Mynydd Ty-talwyn Energy Park - Environmental Statement Volume III

Appendix 8.13: BCBC Landscape and Visual Correspondence

From: [Joanna Berlyn](#)
To: [Joanna Berlyn](#)
Subject: FW: Mynydd Ty-Talwyn Energy Park - Revised Landscape Design
Date: 14 November 2025 22:24:46
Attachments: [image001.png](#)
[image002.png](#)
[image003.png](#)
[image004.png](#)
[image005.png](#)

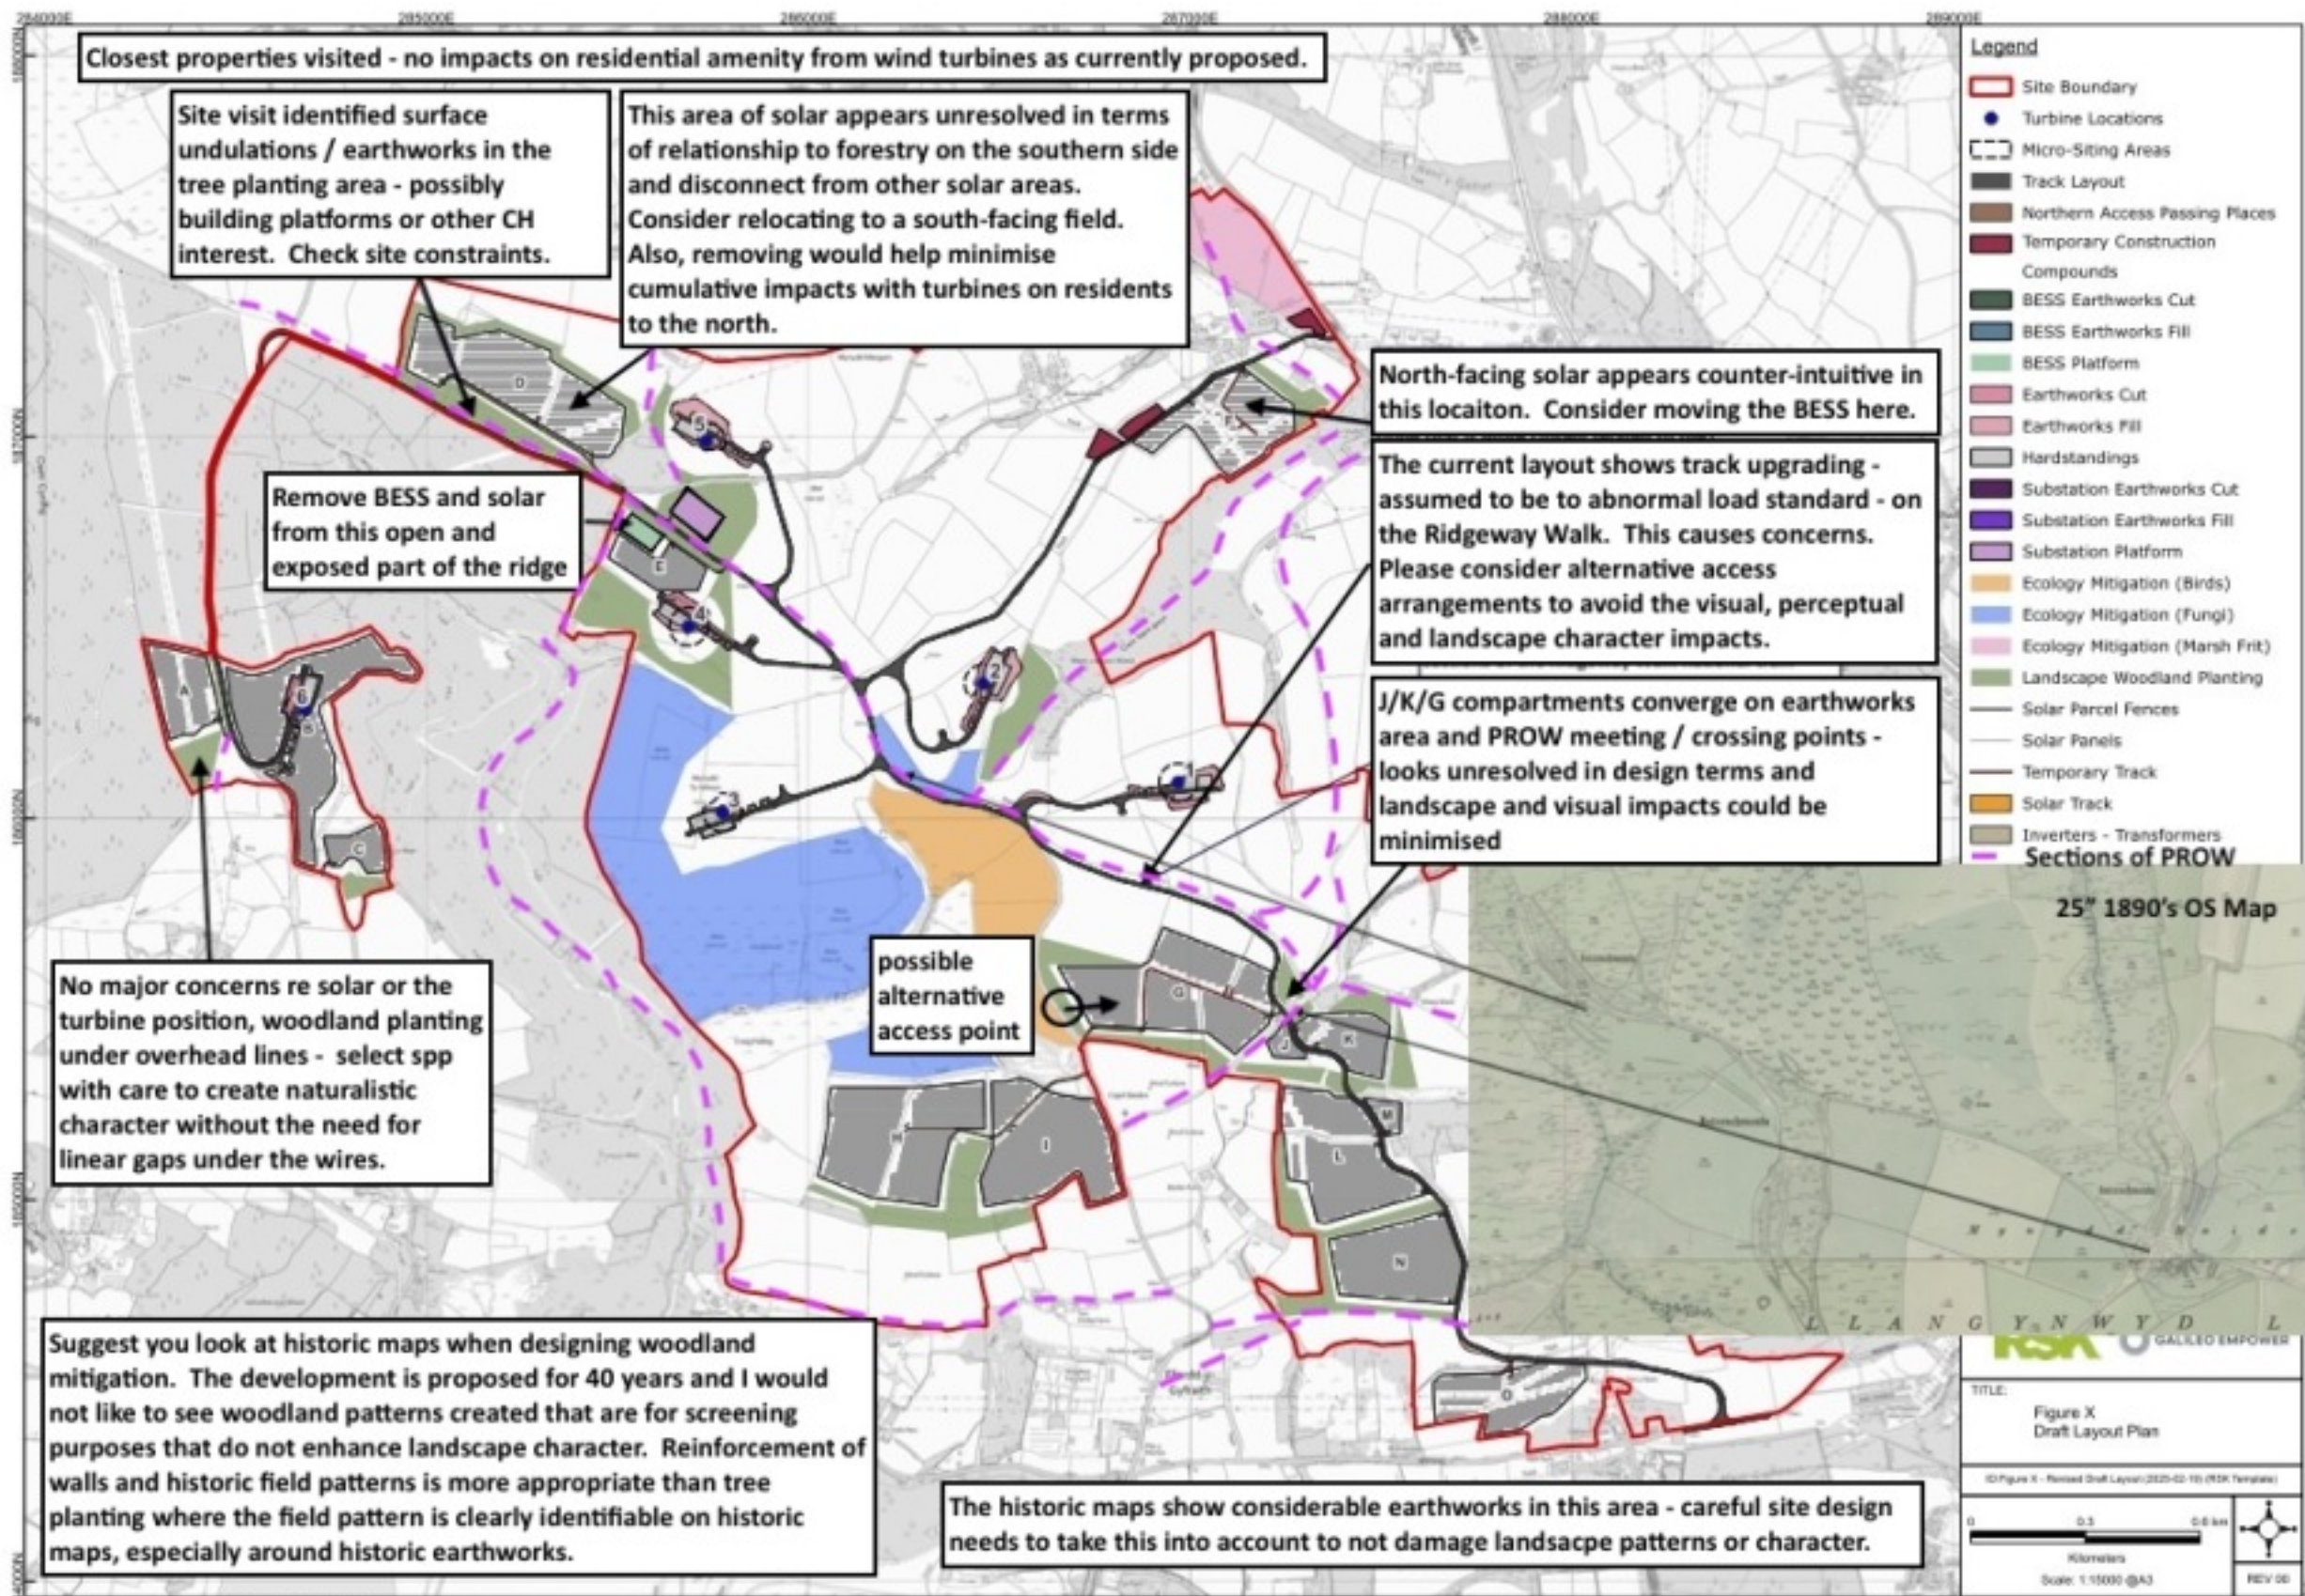
- Substantial issues remain. Please see attached diagram where I set out my original concerns.
- I would like to see the solar and BESS removed from the ridge at D & E. These are impactful on landscape and visual receptors. The developer will argue that from the viewpoints the impact is not so bad; but when you are on the ground and experience the change from the whole Ridge way walk route and the local landscape with strong evidence of time-depth, the impacts are too high.
